**Comparative Life Cycle Assessment for  
Greenhouse Gases (GHG)**

**SLNGaz Project**

**Stolt LNGaz Inc.**

**Project n°617039-14\_V-03\_FINAL**

Figure 2-1: Project scenario

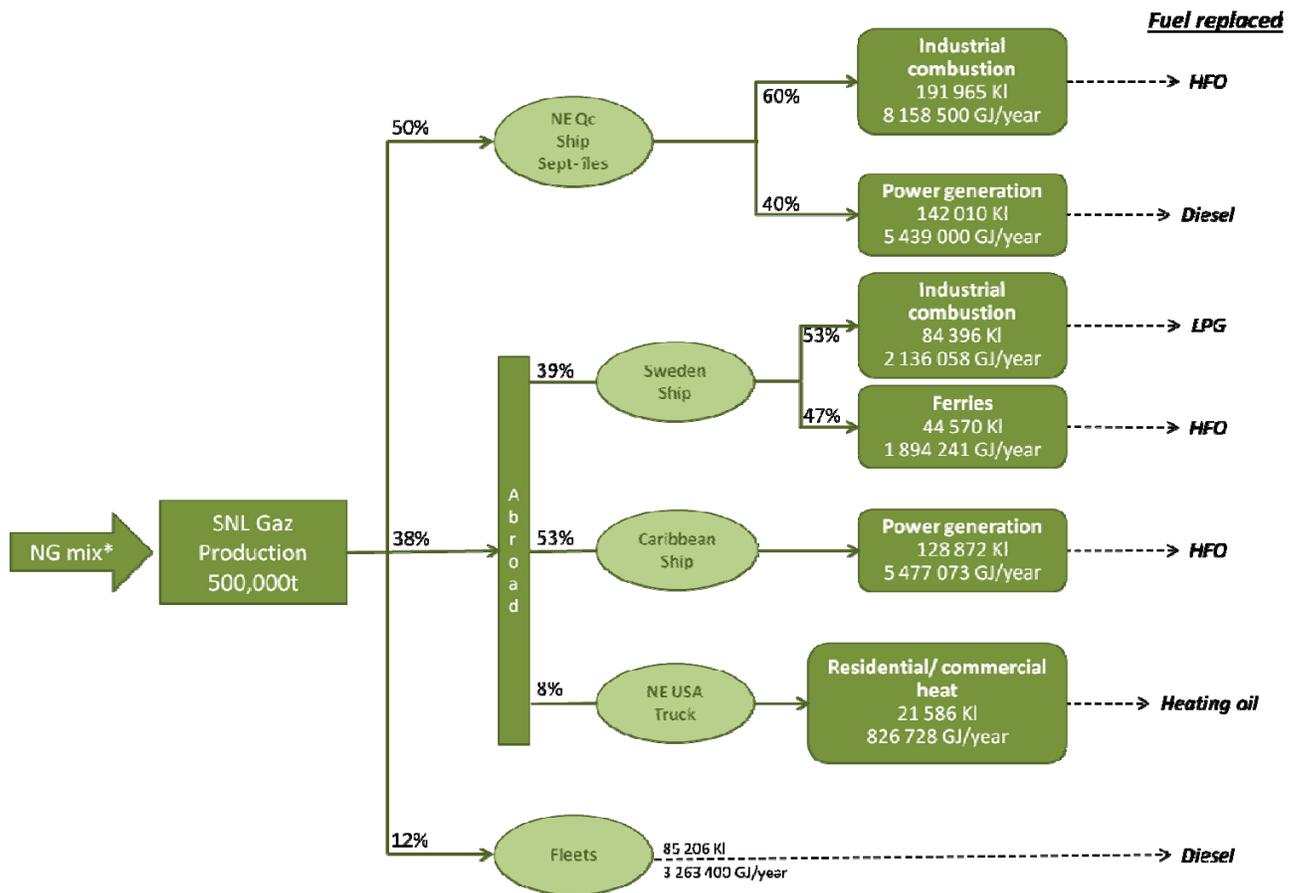
7	DO	2.1	“Carbon and CAC emissions are the environmental impacts.” Replace “Carbon” with “GHG”.	● Modified as recommended.	Satisfactory.
8	DO	2.2	Figure 2-1 is not introduced in prior text and requires better explanation.	● Figure 2-1 is now introduced and described.	Satisfactory.
9	PR	2.2	The scenarios should be better detailed in relation with Figure 2-1. The readers have difficulty to follow the reference scenario for each of the geographical contexts. Authors should provide background information for each geographical context (Quebec, USA, Sweden and Caribbean).	● Has been addressed as per question number 5.	Satisfactory.
10	PR	2.2: Figure 2-1	The defined system assumes that the LNG will replace different types of energy sources but doesn't evaluate what will happen to these replaced energy sources. Therefore, the authors inherently assume an ideal case scenario in which the displaced energy	● An attributional LCA has been performed, which assumes that the fuels being replaced will no longer be produced if there is no a demand for it. This is now stated in the report.	Satisfactory.

**Figure 2-2: System boundary – Activities and processes**

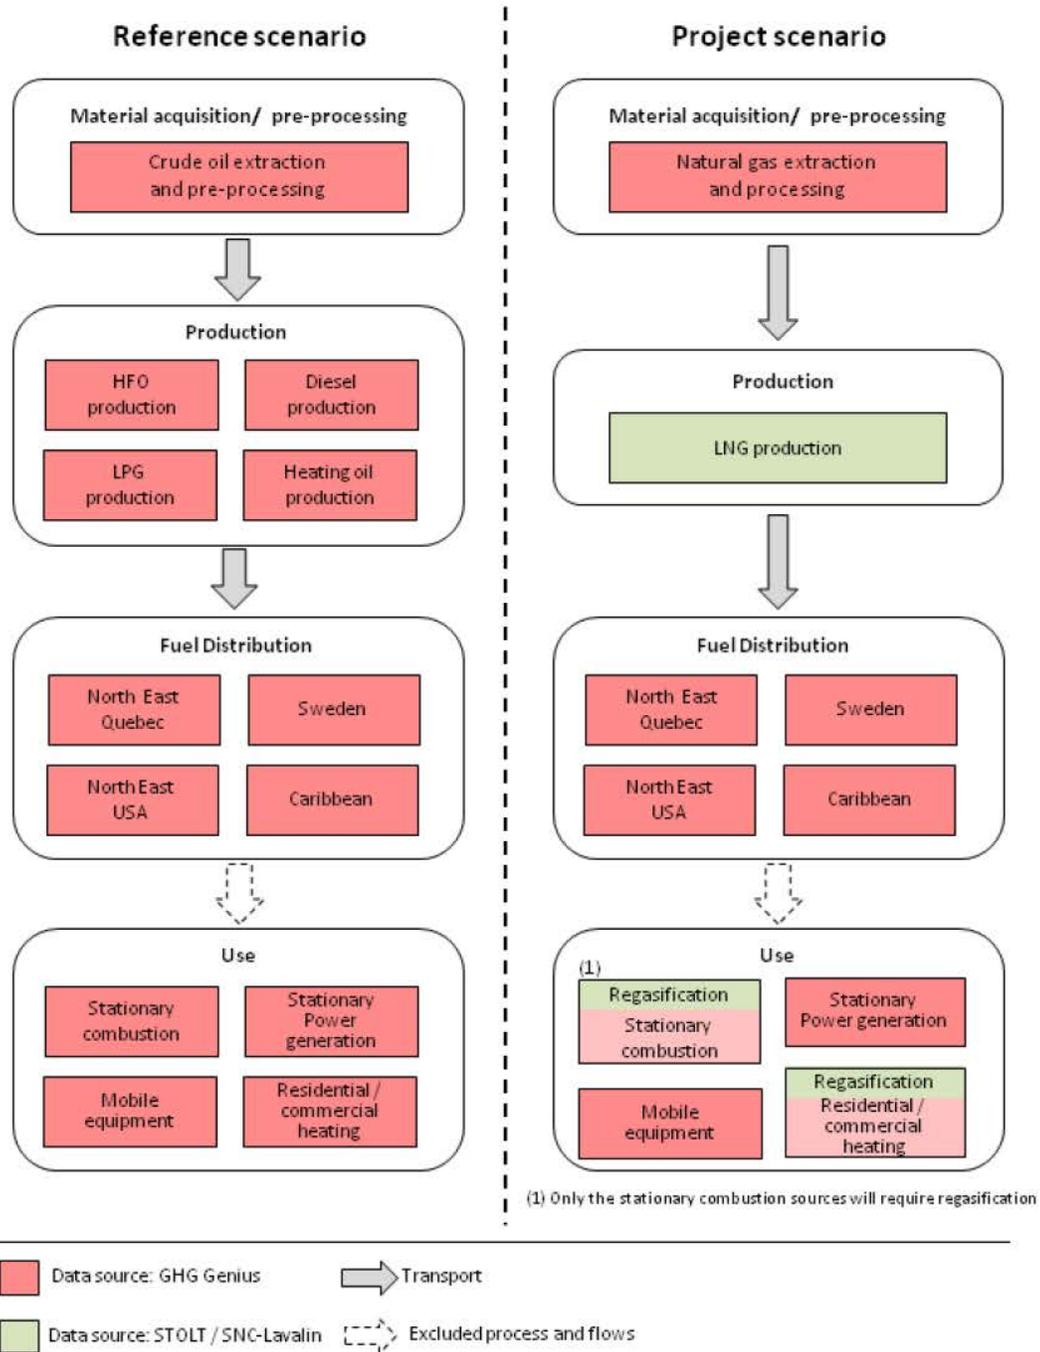
25	PR	2.2.1	The authors included the “ <i>heating oil production</i> ” in the system boundaries (Figure 2-2)? Why is it not mentioned in most places where alternative fuels are enumerated (e.g. section 2.2 and Table 2-2)? The description of alternative fuels should be consistent throughout the report.	● The heating oil used is designated as ULSD. This section has been updated to be more consistent.	Satisfactory.
26	PR, DO	2.2.1	Do emissions in the “end of life” stage correspond to combustion emissions? These emissions should actually be considered in the “ <i>use phase</i> ”. While the authors state that their study is “cradle to grave”, it is erroneous as no end of life processes (e.g. disposition of	● Emissions for the combustion stage are included in the USE stage.  The study is cradle-to-grave, from well head to fuel use. The product end of life being the usage of the fuel.	Satisfactory.
